City of Plymouth Planning Commission Regular Meeting Agenda Wednesday, February 9, 2022 – 7:00 p.m. City Hall & Online Zoom Webinar

TO: City of Plymouth Planning Commission
FROM: Sally M. Elmiger, AICP, LEED AP
DATE: February 3, 2022
RE: Westborn Market – Revised Site Plan for Parking Lot Expansion

**Planned Unit Development
For
City of Plymouth, Michigan**

SITE/DIMENSION PLAN

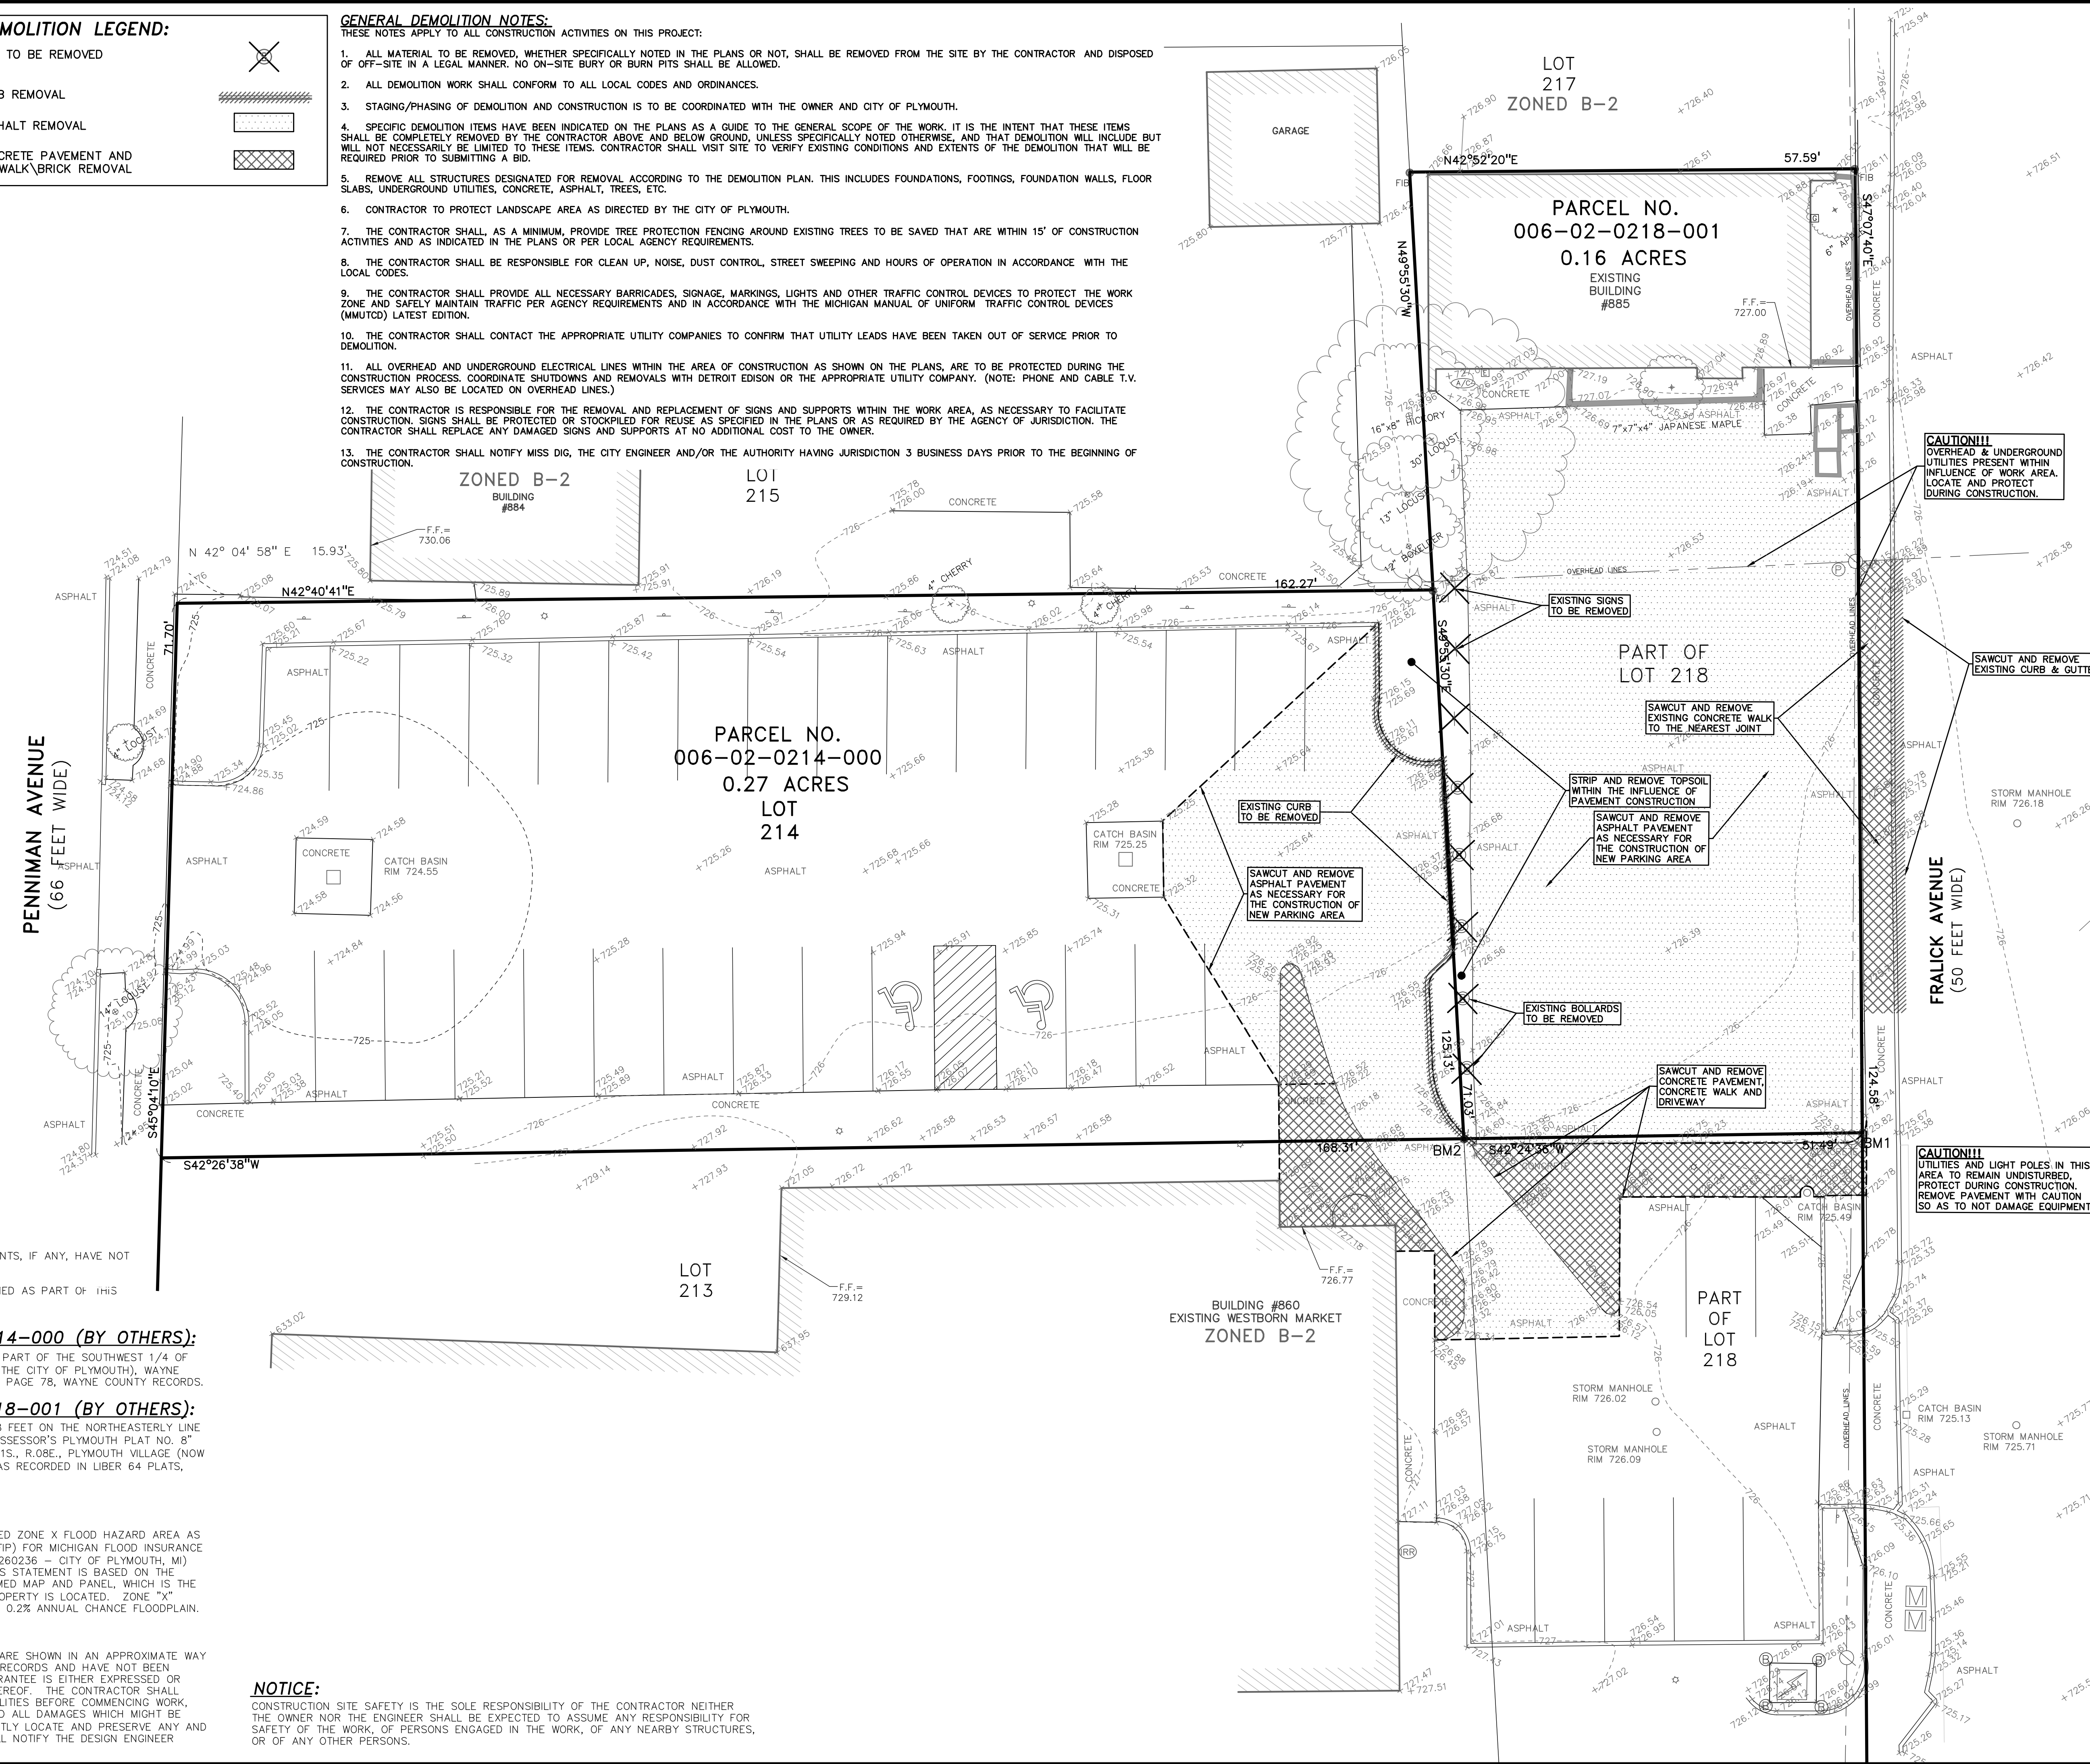
3. **Requested revisions to the plans included the following:**
 1. **Add second barrier-free space to existing westerly lot.** *These spaces are indicated on the revised plans.*

3. **Narrow proposed driveway to allow for longer landscape islands adjacent to Fralick sidewalk.** *The revised plans shows that the landscape island on the west side of the new Fralick driveway has been elongated, as suggested. This additional landscaping space helps screen the lot from Fralick, and adds to the parking lot landscaping requirement.*

4. **Widen proposed sidewalk along east side of new Fralick lot from 5-feet to 7-feet wide to accommodate vehicle overhang.** *This change has been made on the revised plans.*

5. **Eliminate existing sidewalk between two rear lots for reasons enumerated and replace with 7 x 50 foot planting bed.** *This change has been made on the revised plans.*

6. **Eliminate small sidewalk opening and move proposed ornamental tree to large planting bed to north.** *This change has not been made; however, we leave it up to the property owner if they prefer this layout. In our opinion, it doesn't present any difficulties in use of the sidewalk; however, it doesn't provide a very hospitable growing area for an ornamental tree.*
7. **Increase interior parking lot landscaping area by 121 sq. ft.; recommend meeting this requirement with large landscape bed located between two Fralick lots.** *This has been accomplished by creating the large planting bed as described in "6." above.*
8. **Provide photometric plan so that lighting intensity can be evaluated.**

In summary, the revised plans have addressed the comments provided by the Planning Commission. We would recommend that the site plans be approved with the following conditions:

1. Applicant submits paperwork to combine the parcels, as required in the original site plan approval, before building permits are issued for this project.
2. Building Official to determine requirement of barrier-free space in lot behind Westborn Market building.
3. Building Official work with applicant to reduce light levels along Fralick, in the vicinity of double-headed fixture, so that they are within the 1.9 fc maximum permitted on this site.

Plan View - PARKING AREA LTG VALUES 5' AFG
Scale - 1" = 30ft

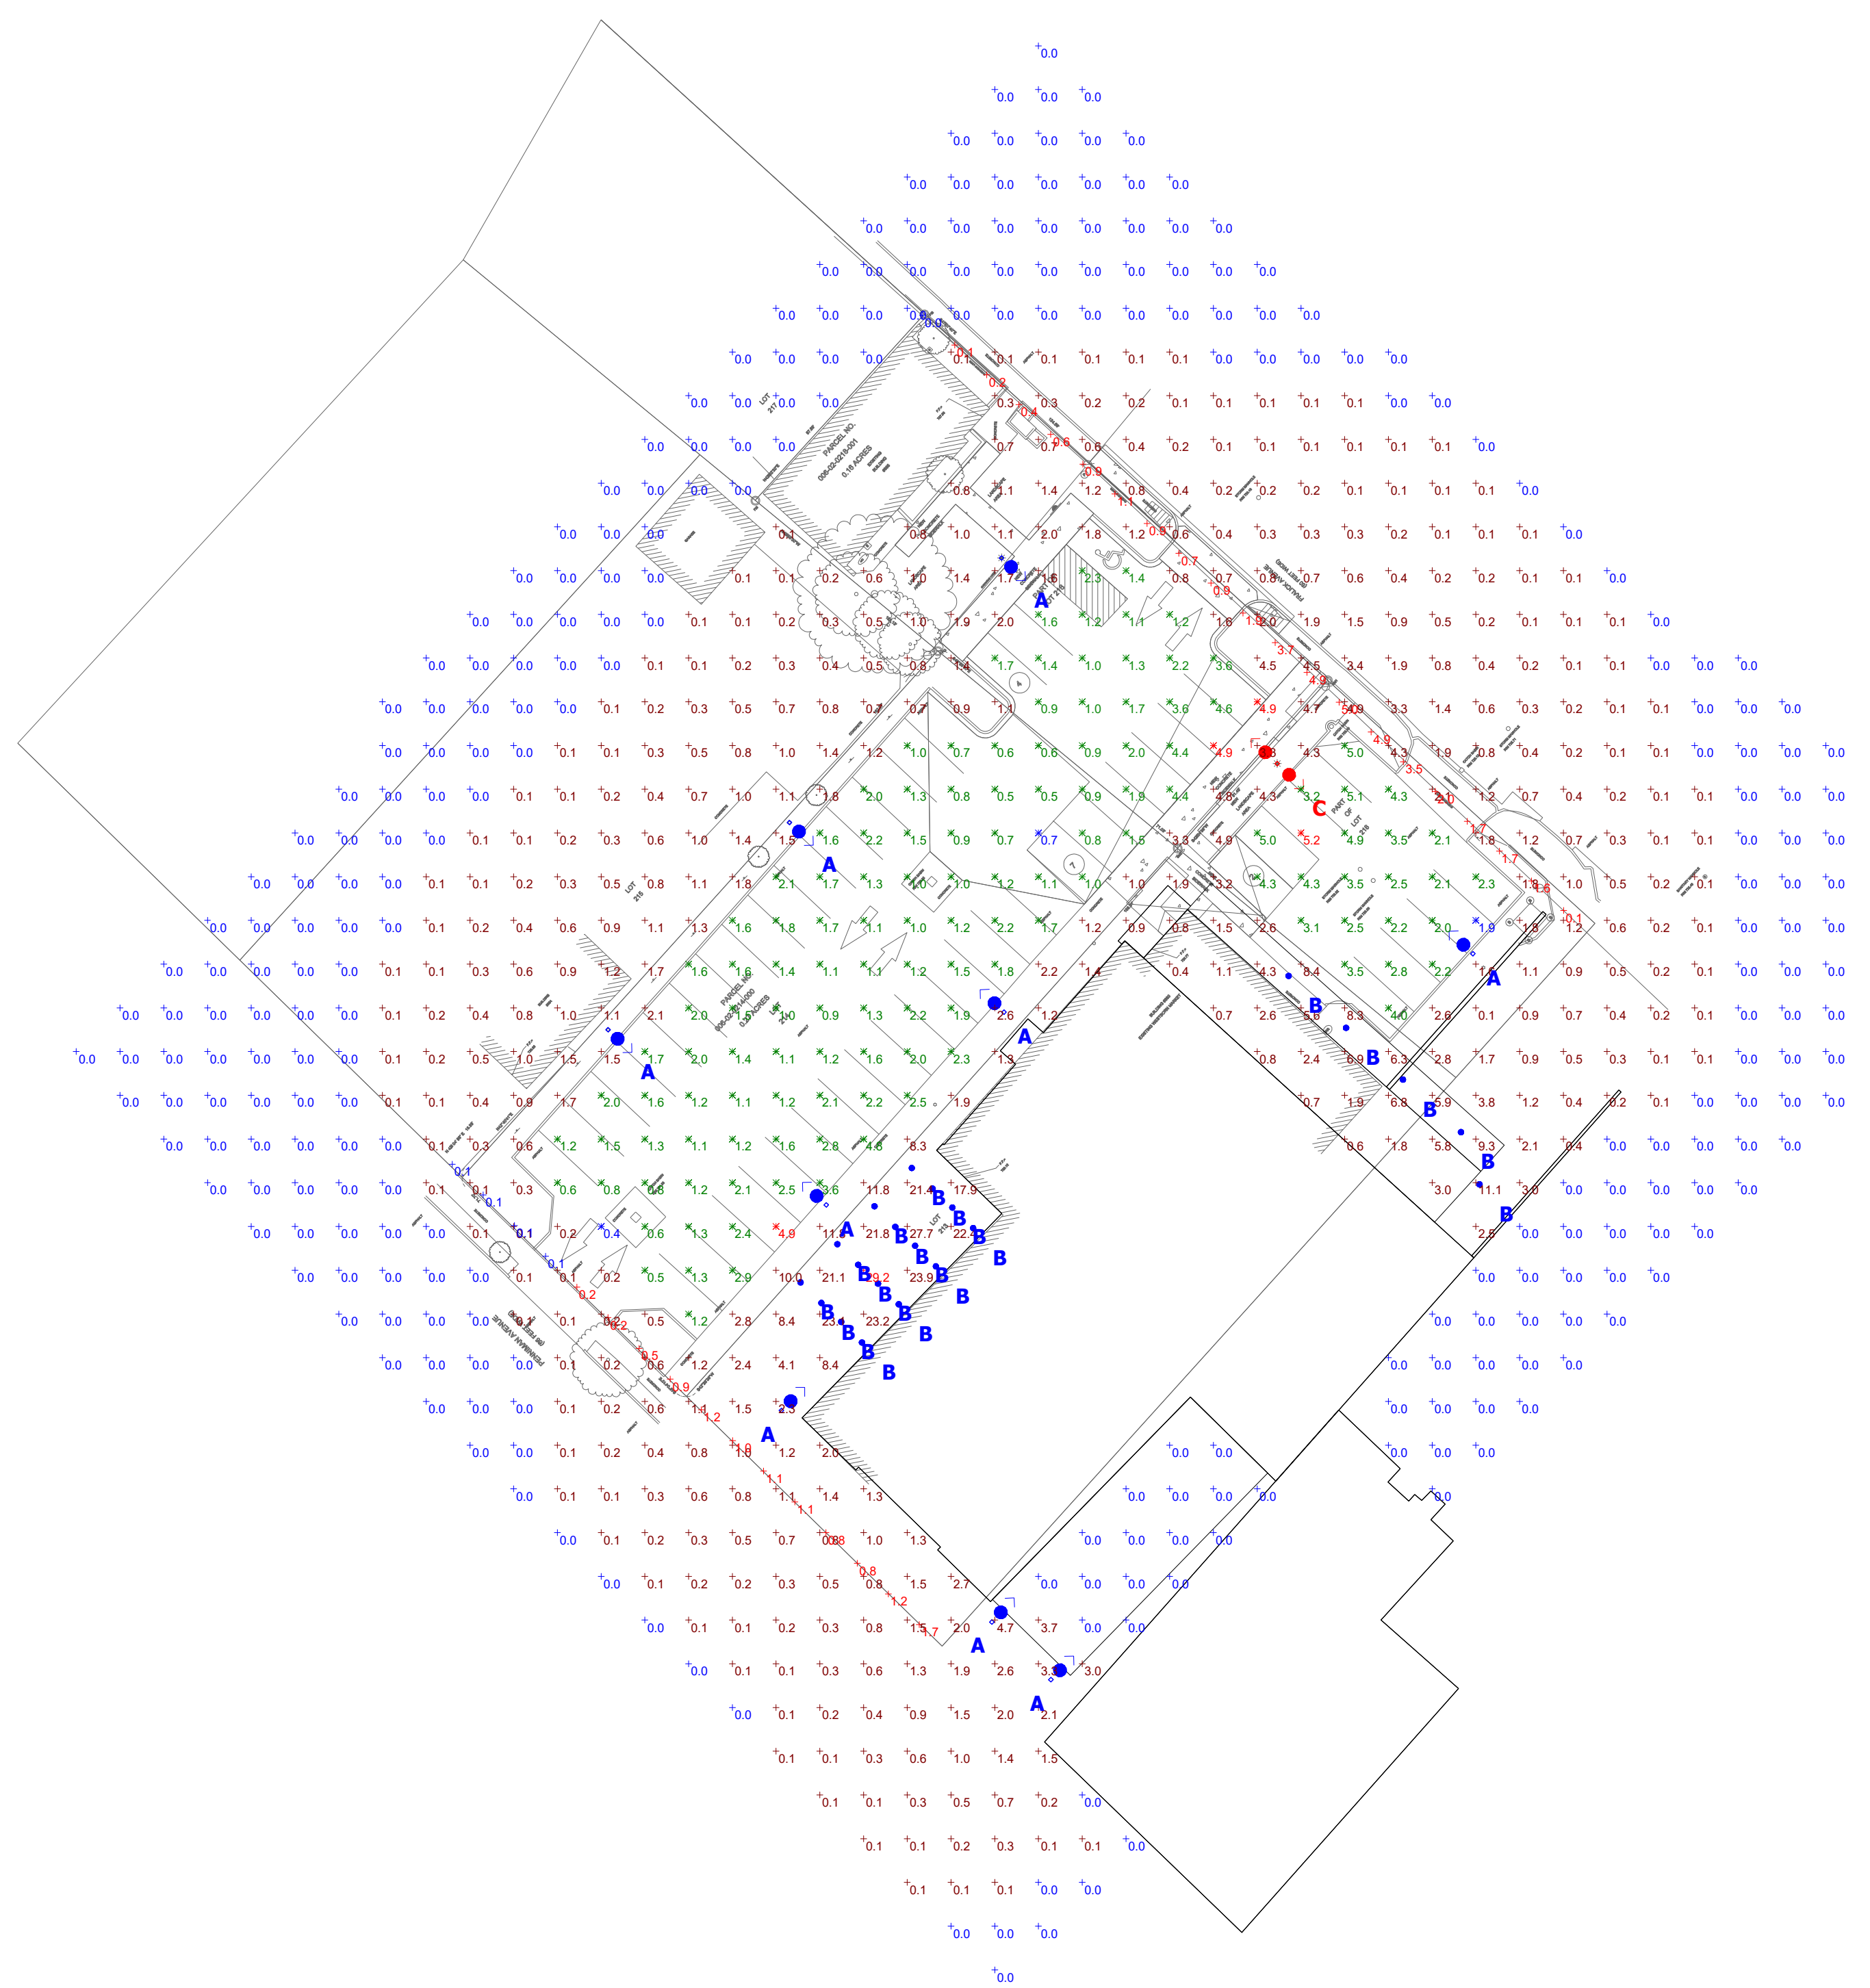
A photometric plan has been submitted. The ordinance contains the following requirements for lighting intensity:
